**TECHNICAL BULLETIN**  
**LTB00823NAS1**  
**28 SEP 2015**

**SECTION: 204-00**

**'Creak' Noise From Stabilizer Bar Bushing-Front**

E182199

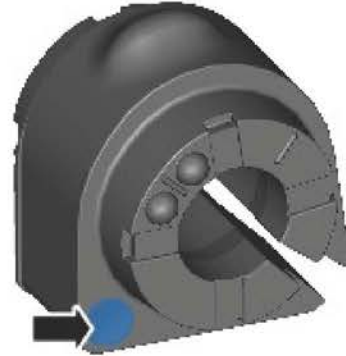
1  **CAUTION: lubricant must NOT be used when installing the new stabilizer bar bushing-front.**

**NOTE: the new stabilizer bar bushing-front can be identified by a green painted dot in the area shown.**

Install new stabilizer bar bushings-front (see TOPIX Workshop Manual section 204-01).
